merit industries, inc.

FIELD BULLETIN

Date: 07-30-01

- Issue:** The thumbscrew on the bottom bill acceptor clamp could interfere with the wires of the bill acceptor.
- Games affected:** Elite MAXX™ with integrated bill acceptor model numbers: G20-106-304-02, -04, -06, -08, -10 and G20-106-307-02

FIGURE 1: LOCATION OF THUMBSCREW ON BILL ACCEPTOR CLAMP

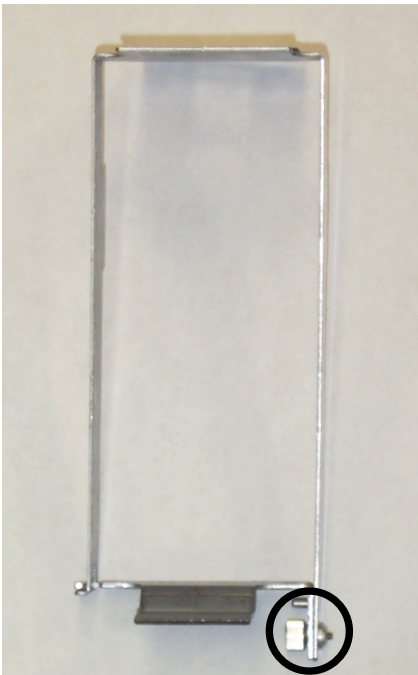
- Symptoms:** The thumbscrew protrudes past the bracket.
- Cause:** The thumbscrew on the clamp is too long.
- Solution:** If you have an Elite MAXX™ with integrated bill acceptor, check the thumbscrew on the bottom bill acceptor clamp (see Figures 1 and 2). If the thumbscrew in your game protrudes past the captive nut on the bracket, contact Merit Industries Customer Service at 1-800-445-9353 or 215-639-4700 to receive a new clamp, which will be equipped with a shorter thumbscrew. Please have your game model number and serial number ready when you call. Be sure to also inspect the wires near the bill acceptor to ensure they have not been damaged. Contact Merit Industries if the wires are damaged.
